Subject: Response to CALFED Ecosystem Restoration Program's external review of *Northern Pike Containment System at the Outlet of Lake Davis on Big Grizzly Creek*

External Review Form
CALFED Ecosystem Restoration Program
Northern Pike Containment System at Lake Davis

Reviewer: Darryl Hayes, P.E.
2485 Natomas Park Drive, Suite 600
Sacramento, CA 95833
Phone: (916) 286-0402

Figure 1 – Northern Pike Embryos

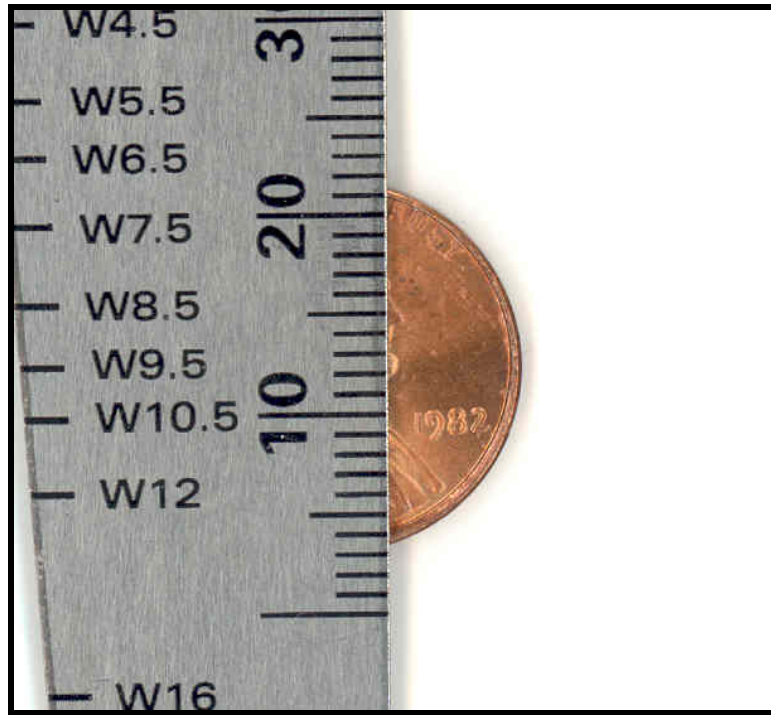
There is no documentation on the appropriateness of using 1 mm opening strainers to prevent all lifestages from exiting the outlet. While this mesh is about the same size or smaller than the eggs, larvae may be smaller. The probability of survival through this system is likely very small, but without data to back this up, 100 percent fish kill should not be expected. A pilot test to look at survival of surrogate fish and egg survival through various sizes of mesh at similar pressures and velocities in a small strainer unit would be advisable if there is time. If this is not possible, different mesh size baskets could still be exchanged with those planned for purchase if necessary. Some biological testing of the system should be completed following project implementation to verify the effectiveness since this project should be viewed as a full scale pilot project. **Lake Davis Fish Containment Committee Response:**

Figure 1 is a picture of three northern pike yolk sac embryos lying next to a penny to indicate scale. Figure 2 is an image of a penny lying under a metric ruler, showing that the numeral 1 in the date is approximately 1 mm in height, and that the penny is approximately 19 mm in diameter. Referring back to Figure 1, it is estimated that the pike embryos are approximately 8 to 9 mm in length. The head is estimated to be approximately 1 mm in diameter.

From figure 1, the yolk sac embryos are estimated to be 8 to 9 mm in length with a head diameter of approximately 1mm. At this size, it may be possible for the embryo to pass through a 1 mm opening; however, reference 2 indicates that the embryos attached to plants by adhesive glands on the top of their heads which decreases the possibility of this life stage passing through the 1 mm filter. At the end of the embryonic period fry are 0.45 -0.51 inches (11.5-13mm) long and become free swimming larvae.

The proposed 1 mm screen size appears adequate for containment of pike eggs and larval sized juveniles over 10 mm. There is a small chance that yolk sac embryos could be discharged through a 1 mm screen if they don't attach to vegetation upon hatching and are subject to a flow pattern in the reservoir that directs them to the outlet. Since the reservoir outlet is deeply submerged and hydraulically distant from prime pike spawning habitat, it is unlikely that embryonic pike would survive predation and/or discharge through the reservoir outlet during the short period of time that they are of a size that could pass through a 1 mm strainer screen.

Therefore, we conclude that 1 mm is an appropriate strainer mesh slot size for containment of the early life stages of northern pike.
